ADDENDUM #2 TO BID #20-001

BID NUMBER: 20-001

PROCUREMENT FOR: Brick Chimney Road Improvement Project

CROSSLINE PIPE INSTALLATION TYPICAL SECTION AT APPROXIMATE STATIONS 126+61, 129+35, 129+75, 139+75 AND 140+35 (NOT TO SCALE)

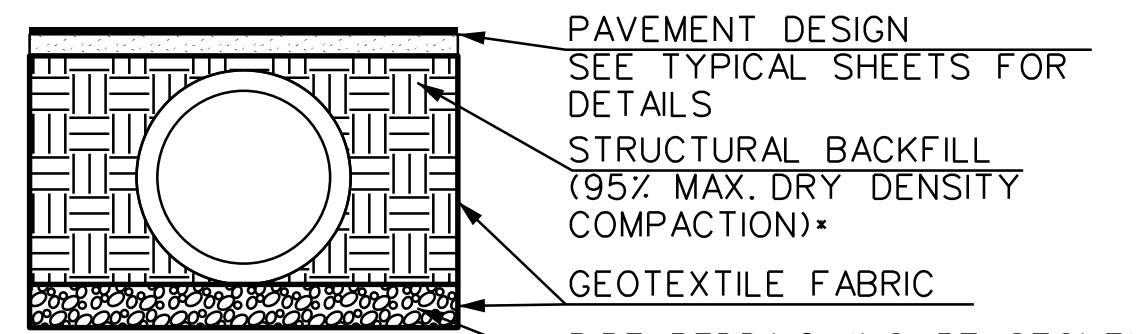
On sheet 5, there is a detail on the crossline pipe installation. What do you mean by pipe bedding #57 stone, 24” minimum thickness, beginning 12” below pipe? I don’t quite understand that, beginning 12” below pipe.

Question 3: (Question 9 from Addendum #1)
Also, on that detail it says do not use sand fill within 2 vertical ft. of the water level at the time of construction? How will that be paid for? The water table probably fluctuates.

Response: Cross line pipe detail has been updated, see updated plan sheet 5 included in this addendum.

Response: **This requirement has been removed. See updated plan sheet 5 included in this addendum.**
